Date  
11 December 2013

Reference number  
230151

Subject **Life City Wollongong - Review of Traffic and Transport Assessment**

**Figure 1. Nolan Street view north at Warwick Street (Source: Google Maps 2013)**

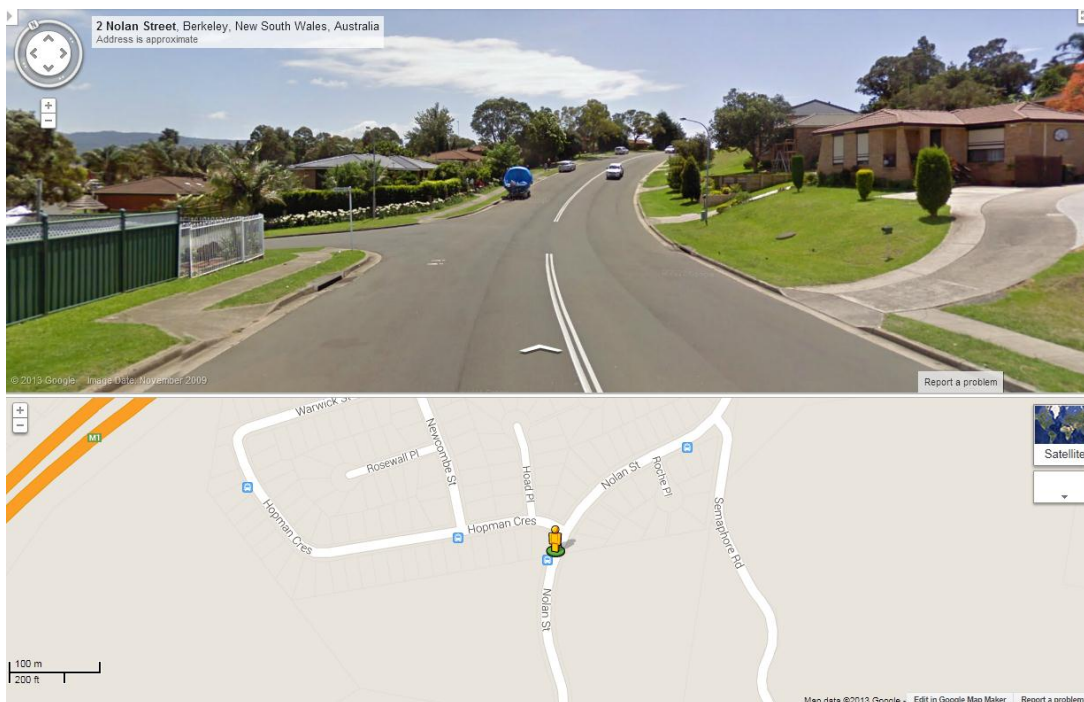
Nolan Street has a wide cross-section with width for a single lane plus a parking lane in each direction, as shown in Figure 1 and Figure 2.

While it has residential frontages along its length as can be seen in Figure 2, Nolan Street serves an important collector function including carrying bus services. GHD identifies from surveyed volumes that Nolan Street is currently carrying around 4,000-4,600 vehicles per day.
